**CITY OF MARTINEZ**

**CITY COUNCIL AGENDA  
March 20, 2013**

**TO:** Mayor and City Council  
**FROM:** Philip Vince, City Manager  
**PREPARED BY:** Dina Tasini, Contract Planner  
**SUBJECT:** Public Hearing to Consider and Possibly Take Action on a Planned Unit Development for a 6.83-Acre Site with 80 Townhomes and 2 Single-Family Homes.  
**DATE:** March 11, 2013

DATE: OCTOBER 23, 2012  
TO: PLANNING COMMISSION  
FROM: DINA TASINI, CONTRACT PLANNER  
RE: LAUREL KNOLLS - 370 Muir Station Road. (APN# 162-263-006 & 009)

FIGURE 1 | PROPOSED CHANGES TO PAVEMENT MARKINGS

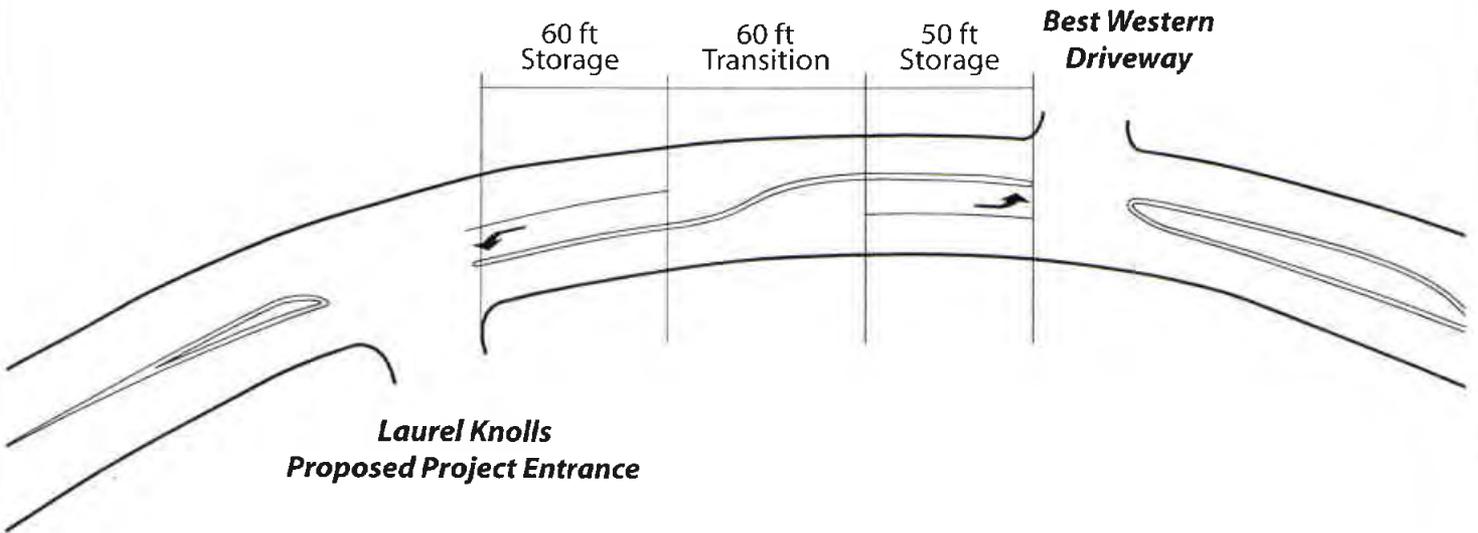
The attached Figure 1 presents the existing conditions and our suggested changes to the pavement markings on Muir Station Road. Please note that we have reviewed the potential queuing for the left turn pockets presented in Figure 1 and the minimum left turn pocket storage of 50 feet (as specified by Caltrans standards) is all that would be required for these two turn pockets. For example, the existing left turn pocket for the left turn from westbound Muir Station Road into the adjacent shopping center has 50 feet of storage and a 40 foot transition.

Section 405.2 of Caltrans' Highway Design Manual specifies that the storage length at an unsignalized intersection "*may be based on the average number of turning vehicles likely to arrive in a 2 minute period.*" Based on the maximum hourly volumes forecast to use the two turn pockets (as presented in Figure 1) the proposed storage for two cars (50 feet) is the most that will ever be needed. Again, it is important to note that the existing two-way left turn lane should continue to operate safely and no changes are required to accommodate project traffic. However, we would suggest the City consider making the changes to the pavement markings shown in Figure 1 if the proposed project is approved.

CONCEPTUAL  
 SITE PLAN

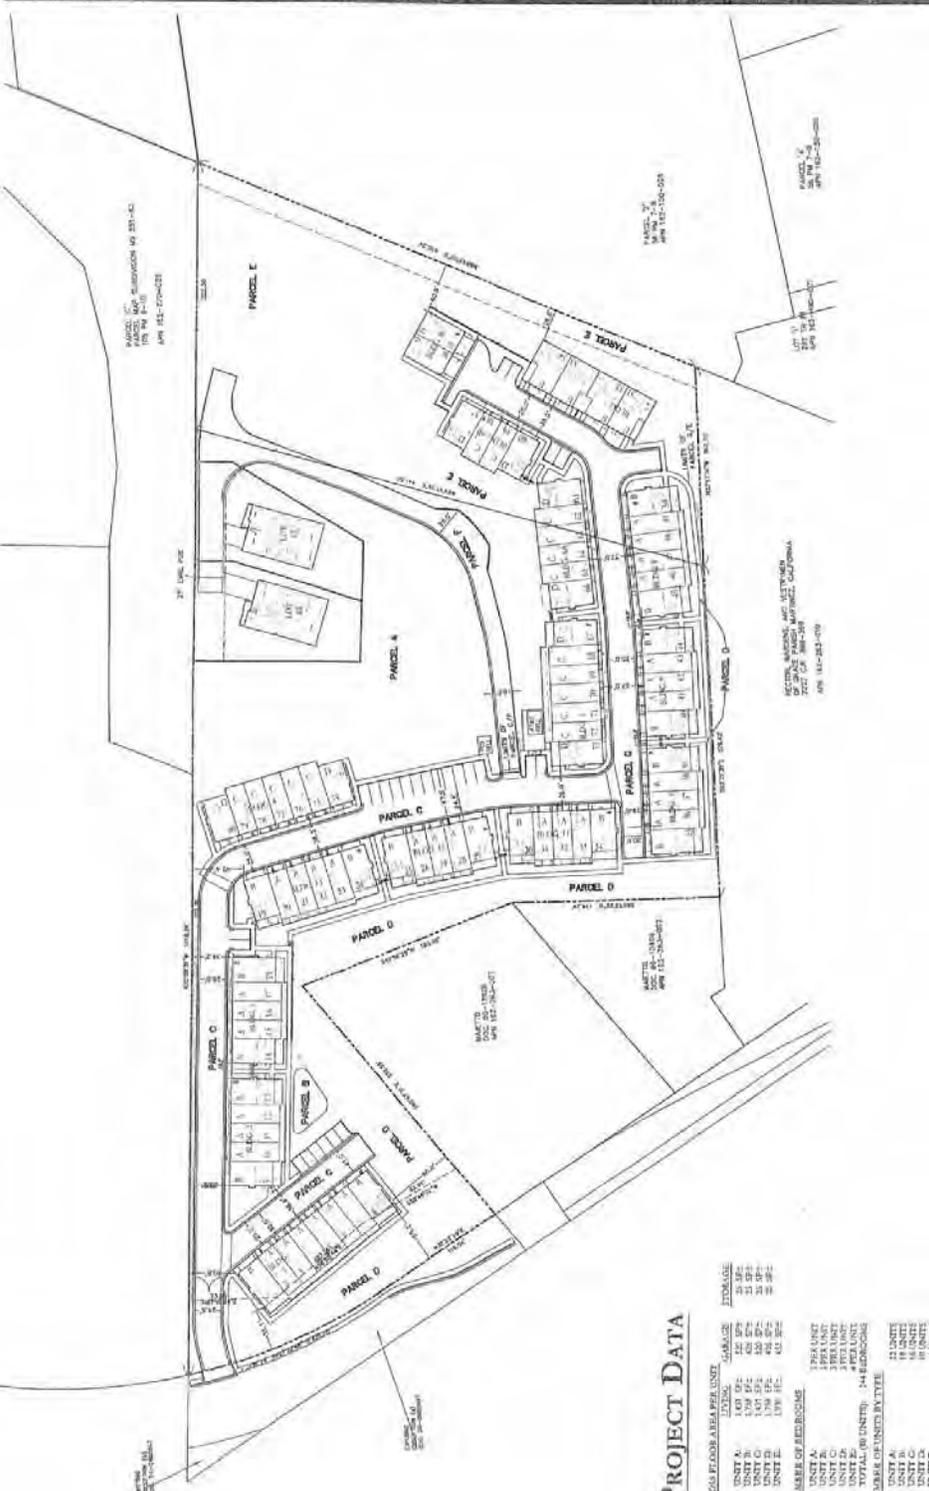
Several Commissioners commended on the “tightness” of the proposed site plan and asked the applicant to consider both a greater setback of the townhome units from the neighboring properties and/or move internal open space areas.

Staff has discussed site layout and setbacks with the applicant. The applicant is reluctant to make changes to the site plan that took close to six months for the Design Review Committed to recommend approval. No changes have been made to the proposed layout since the Planning Commission hearing on August 14, 2012.

REVIEW COMMENTS: I do not recommend approval or moving this project forward to the Planning Commission. Generally, the site design is too tight. The proposed landscape is not sufficient to provide adequate screening, most of the planter areas between and around the buildings are too small, and cannot accommodate the trees. There is no entry landscaping that works with the walks/gate/fencing. Trees are blocking most of the street lighting. The entry gate will not work as shown. The bio-swale at the first corner of the street should be relocated.

- 1. play area and picnic areas have not been well-thought out - the spaces are too small to make the design work. All buildings
- 2. are proposed to be 3-story - the corner units should be reduced
- 3. down to 1 or 2 stories. The entry alleyway should be a
- 4. minimum of 20 ft wide for better lighting and planter spaces.
- 5. This project is not ready for any approval - the applicant is

1. To reduce the vertical massing of Building 8 when viewed from Donaleen Court below, the maximum height of this building shall be reduced from 3 stories to 2½ stories and from 37' to 32'. To further deemphasize the building's height; no more than 50% of the shed roof facing Donaleen Court may include dormers for the building's third level. All such dormers, if any are proposed for the rear elevation of the building, shall have hipped rather than gabled roofs. **(Mitigation Measure Aesthetics 1 and Land Use and Planning 1)**
2. The applicant shall augment the architectural detailing of Building 1's elevations that are adjacent to Muir Station Road and the entry drive to better integrate this structure into the existing visual context and architectural quality of Muir Station Road and State Highway 4.

3. To reduce the visual mass of Building 7 when viewed from the EBRPD's California Hiking and Riding Trail, this building shall not exceed a maximum height of 30' above the access road (with all floors at or above the access road grade), and shall provide a minimum 40' setback from the southerly property line, maintaining a tree planting strip of no less than 20 feet wide that is clear of any planting limitations from the adjacent pipeline easement and the building's roof overhang. The final landscape plan shall include an informal cluster of large evergreen trees that, upon maturity, will fully screen the building's lower levels from the Trail. **(Mitigation Measure Aesthetics 3 Land Use and Planning 1)**

5. To reduce the potential hazards from the constrained maneuvering room and limited line-of-sight in the vicinity of Units 19 and 73, the site plan shall be modified and the access drive realigned, so that a WB-40 vehicle can safely negotiate these two curves to the satisfaction of the City Engineer. **(Mitigation Measure Traffic: 2)**
